UNITED STATES PATENT AND TRADEMARK OFFICE

Office Action Summary

10/596,694

D'ARRIGO, ANGELO

Figure A

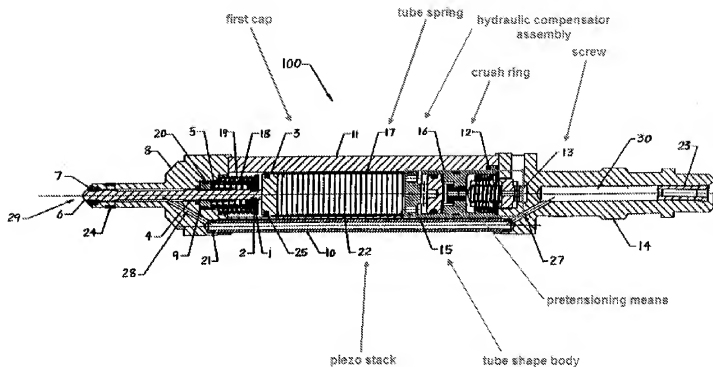
4. Considering claims 1 and 10, Shen (Figure A) teaches a piezoelectric actuator unit comprising: a tube spring (17); a piezoelectric actuator (22), that is inserted into the tube spring, a first cap (3), that is connected to the tube spring at a first free end of the tube spring and which is adjoined by the piezoelectric actuator, a tube-shaped body (15) that is connected to the tube spring by joining and is arranged in the area of a second free end of the tube spring and a means for pretensioning that is supported by the tube-shaped body and pretensions the piezoelectric actuator.

5. Considering claims 4 and 13, Shen (Figure A) teaches a thread in the tube-shaped body and wherein the pretensioning means is a screw (13) that is screwed into the thread.

Figure B

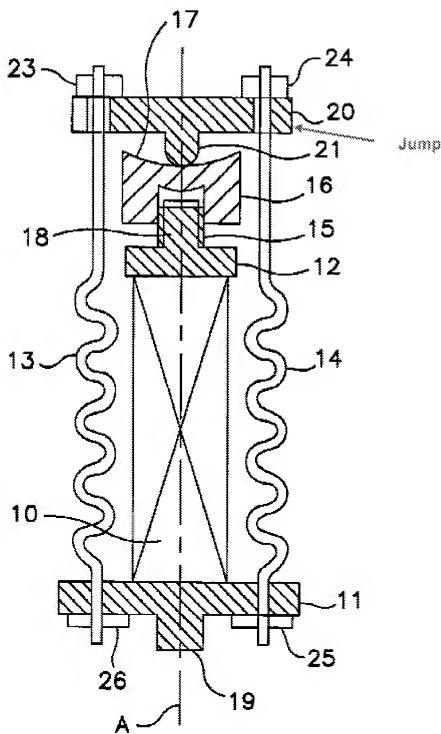
12. Considering claims 6 and 15, Mattes (Figure 1) teaches the tube-shape body has a jump in its diameter on its outer circumference.
